**The Morecambe Offshore Windfarm Generation Assets Development Consent Order
Application**

**Deadline 3 submission by Spirit Energy Production UK Limited
Response to the Applicant's Deadline 2 Submissions**

**EN010121
Unique Reference: 20049981**

Date	22 January 2025
-------------	-----------------

Figure 3.1: Arc of 263 to 90 degrees relative to the existing infrastructure

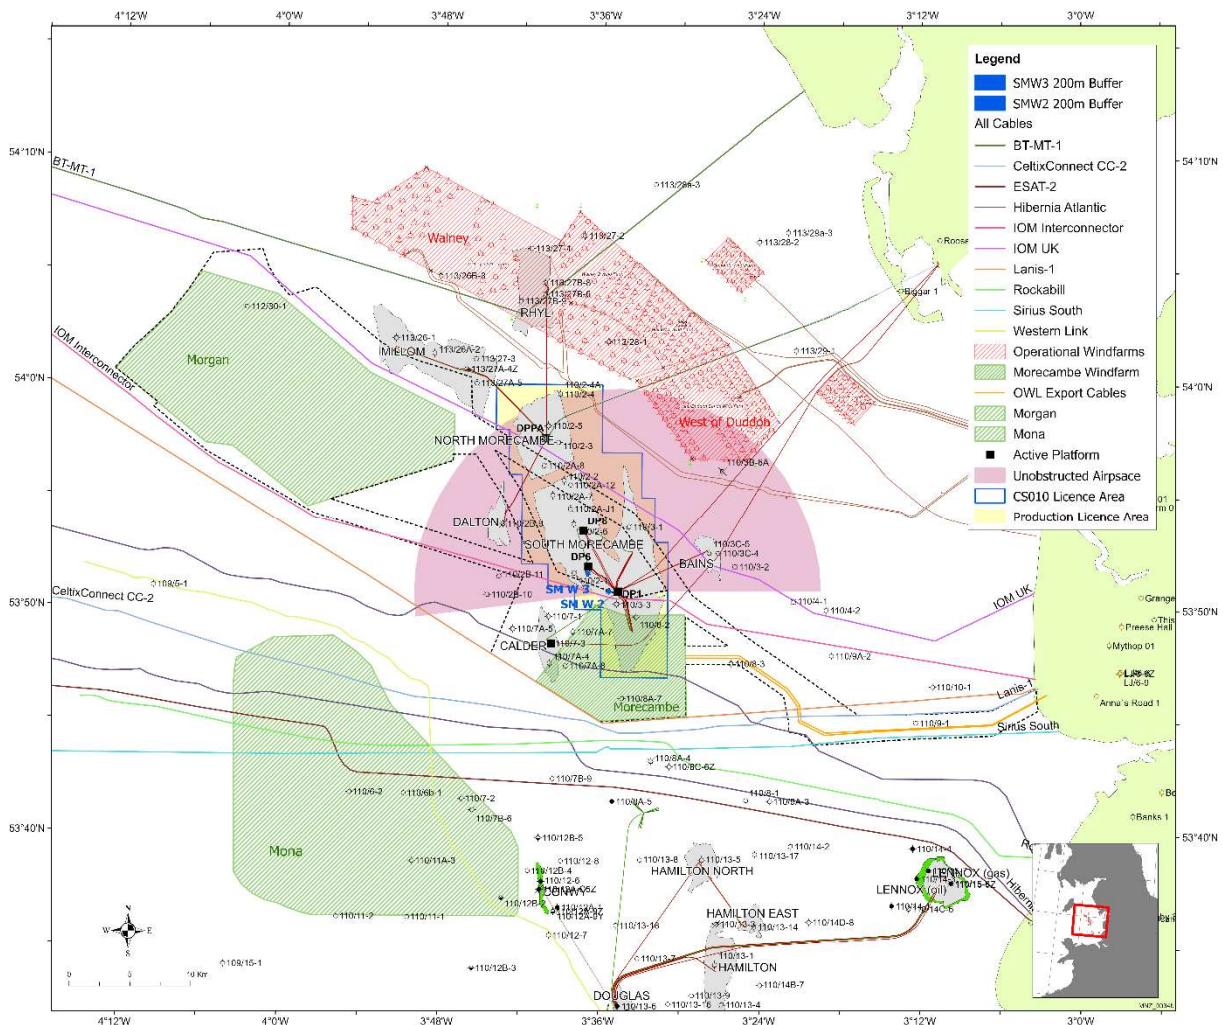
- 3.22 In addition, the Applicant notes that there is an arc of unobstructed airspace 263 degrees clockwise to 90 degrees around CPC (shown in Figure 3.1 – see further below paragraph 3.46) and that this allows take off and landings within this space in night VMC and IMC to and from this arc. The Applicant asserts that:

- 3.23 The Applicant's view is misleading for the following reasons.
- 3.24 Under the proposed CAA regulations (and subject to the response on this matter from the CAA at Deadline 3) Spirit aviation operations will be restricted to no IMC and no night operations which will be enforced due to proximity of the proposed wind farm regardless of the arc sector.

- 3.26 Although the CAA regulations are expected to change, Spirit would emphasise that the 'arc' does not address Spirit's concerns under the current CAA regulations either. The aircraft approach from the arc sector can be considered in both VMC and IMC conditions, however the Applicant has omitted to consider the subsequent take-off would then have to be performed into the opposite sector of 90 degrees to 263 degrees. which is predominantly covered by the proposed windfarm. Such take-off into the opposite sector would not be viable based on the distances calculated for OEI take-off in both conditions unless 3.9nm is available. By the same token, take off would be possible but landing would not as the aircraft will have to approach from the windfarm direction to take-off into the arc.

- 3.28 As mentioned above, Spirit has provided a plan in Figure 3.1 below showing the arc relative to the existing infrastructure map to illustrate this.

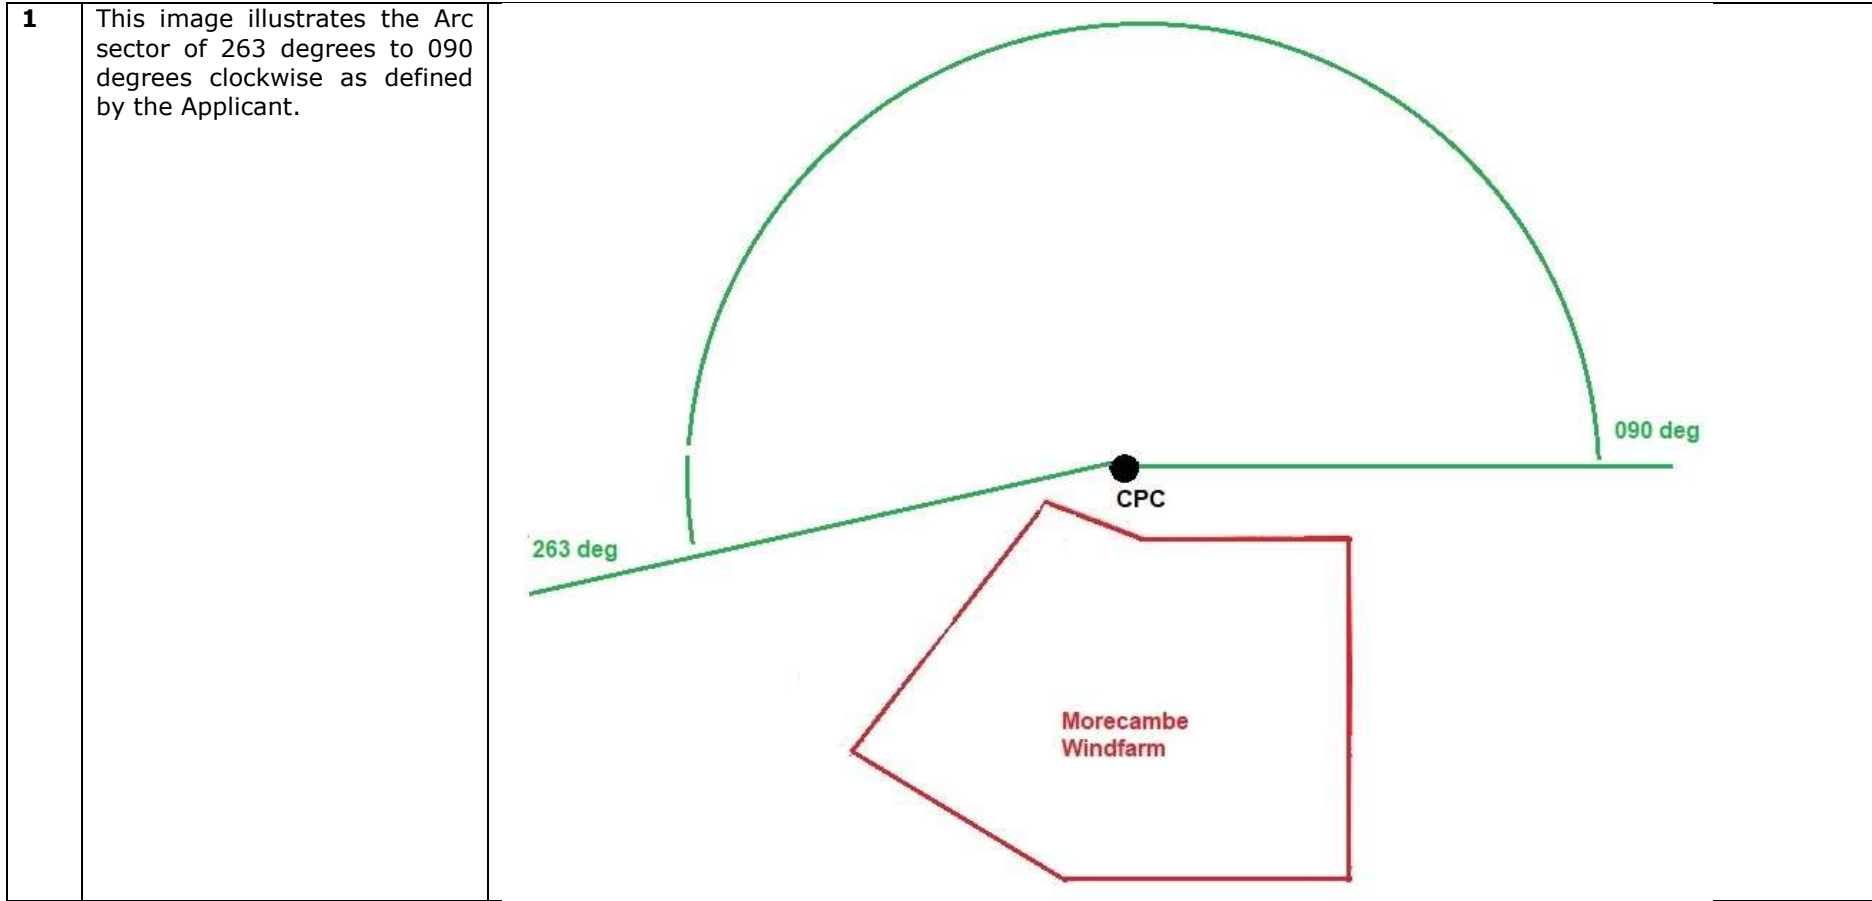
The below diagrams demonstrate why the arc does not provide the extent of unobstructed space asserted by the Applicant.

This image illustrates why there is not an unobstructed arc as asserted by the applicant in the case of winds above 30 kts. With the proposed wind farm Order Limit the sector of 105 degrees to 230 degrees clockwise (purple) is obstructed by the wind farm.

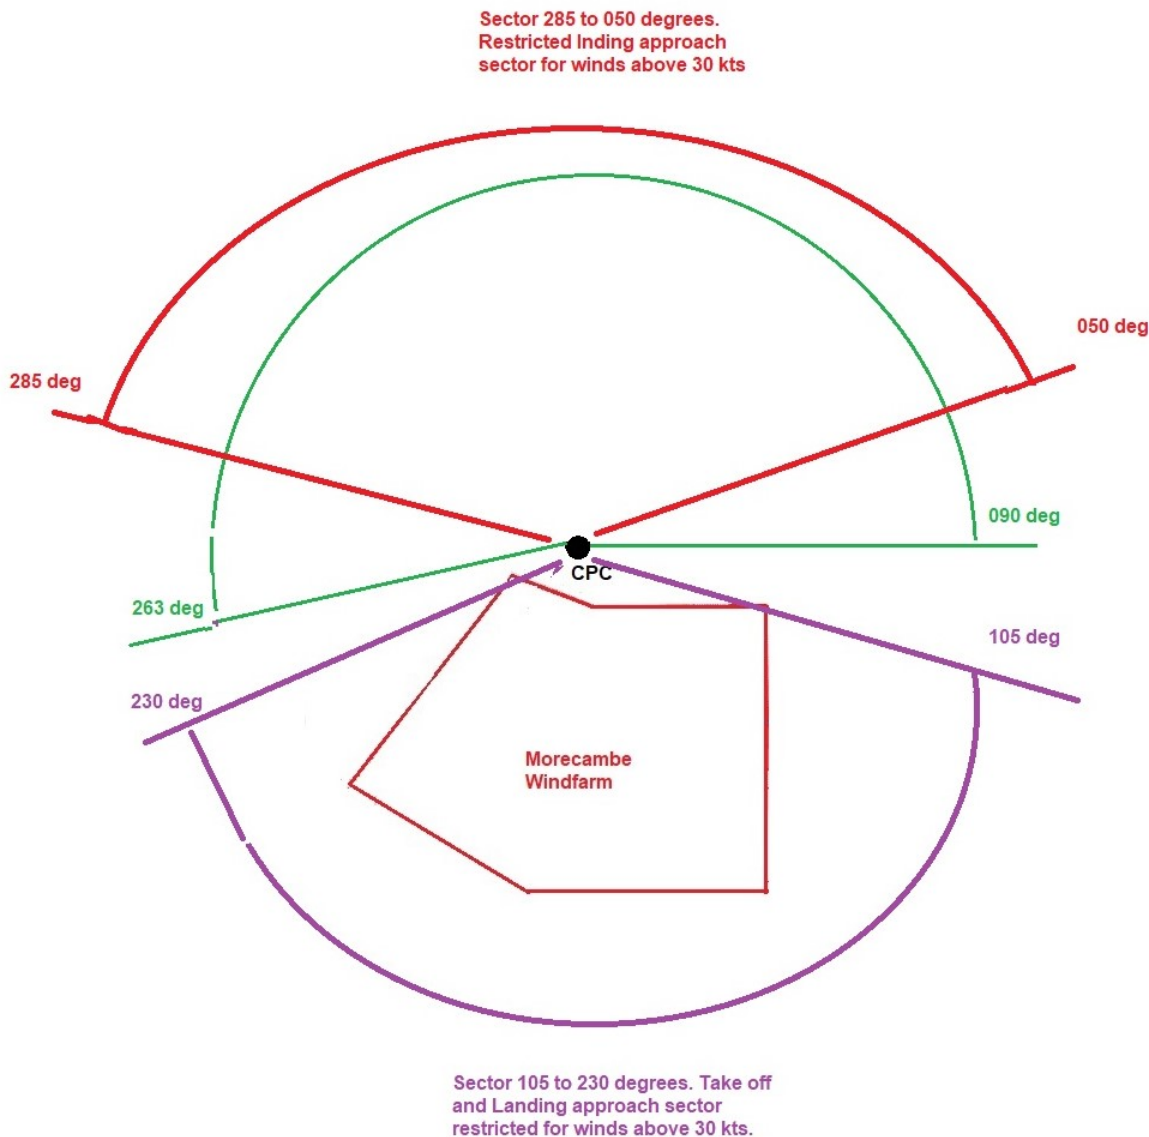
Take-off will be restricted into the purple sector without a 3.9nm buffer zone due to proximity of the windfarm. Due to the fact that you should land and take off into the wind, this means that the landing approach sector of 285 to 050 clockwise (red) could not be used.

Landing approach will be restricted from the purple sector due to the requirement that the aircraft will need to fly over the wind farm (overflying) and make a stabilised approach. Due to the fact that you should land and take off into the wind, this means that take-off into the red sector could not be performed.

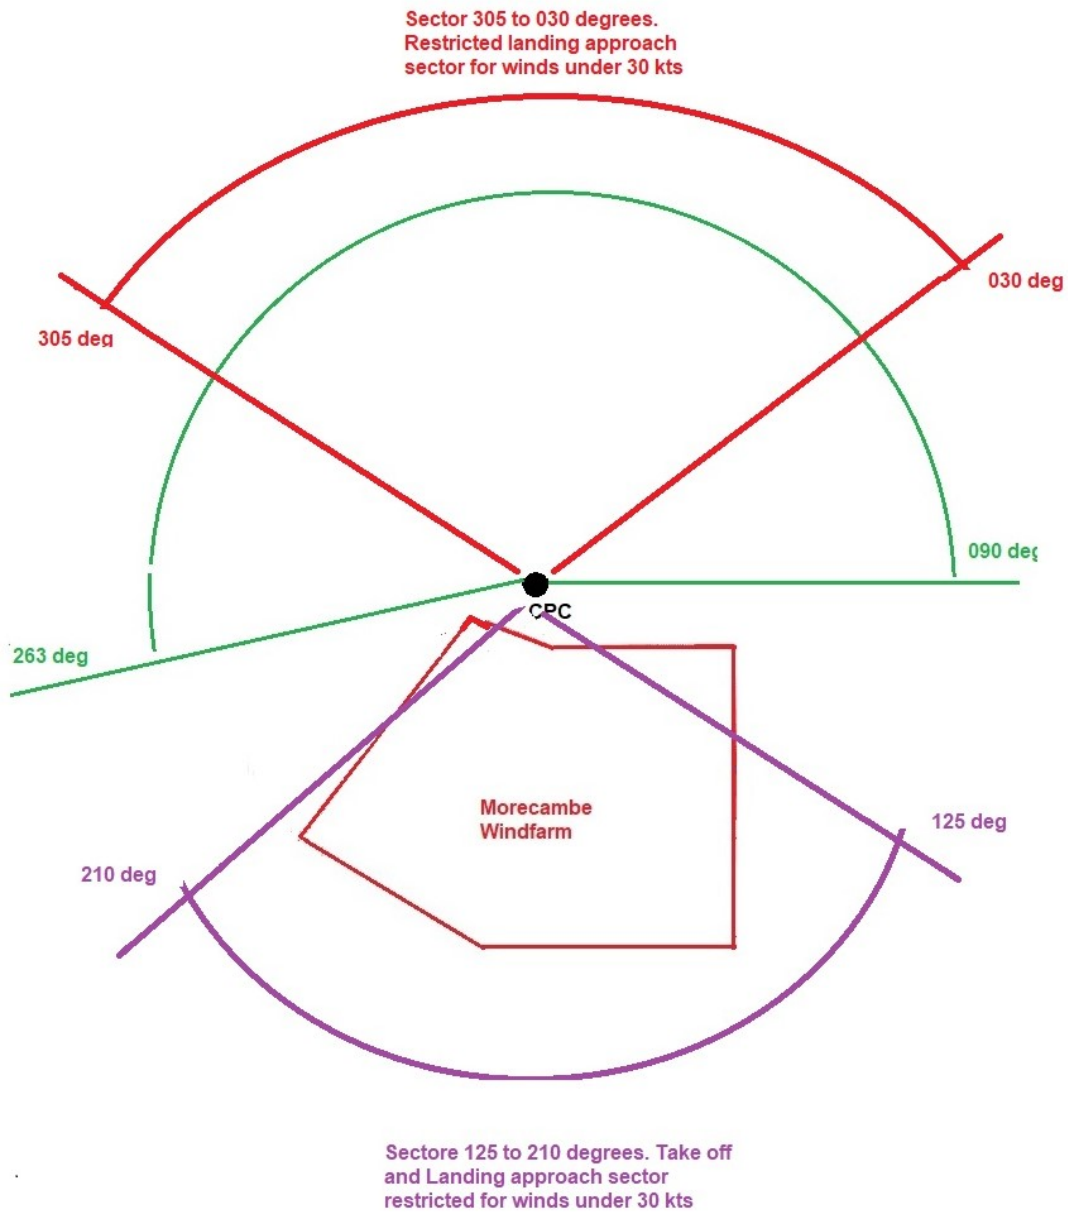
This image that illustrates why there is not an unobstructed arc as asserted by the applicant in the case of winds under 30 kts. The sectors could reduce for winds under 30 kts both sectors (purple and red) can be reduced by +/-20 degrees to the following:
Purple sector - 125 to 210 degrees
Red sector - 305 to 030 degrees

<p>4</p>	<p>In addition to the constraints imposed by the windfarm described above, we also need to factor in helideck limitations.</p> <p>The CPC helideck has an operational limitation outlined on the HCA (Helideck Certification Agency) plate certificate. When the wind direction is coming from the 045 degrees to 135 degrees clockwise area (yellow) then operations are limited in wind speeds of over 20 kts and flights should only be performed under extreme caution or in an emergency only due to possible turbulence.</p> <p>This then results in a wind speed restriction of under 20kts to the landing approach from the 225 to 315 degrees sector (blue).</p> <p>Landing approach from other directions is not limited to 20 kts wind speed.</p>	<p>The diagram illustrates the operational limitations for the CPC helideck based on wind direction. It features a central point labeled 'CPC' with a red polygon representing the 'Morecambe Windfarm' to its southeast. A yellow arc, spanning from 045 degrees to 135 degrees clockwise, is labeled 'Wind direction for helideck limitations'. A blue arc, spanning from 225 degrees to 315 degrees clockwise, is labeled 'Sector 225 to 315 degrees. Landing approach sector for winds under 20 kts. Based on CPC-1 HCA cert.'. Other marked angles include 090 deg, 263 deg, and 315 deg.</p>
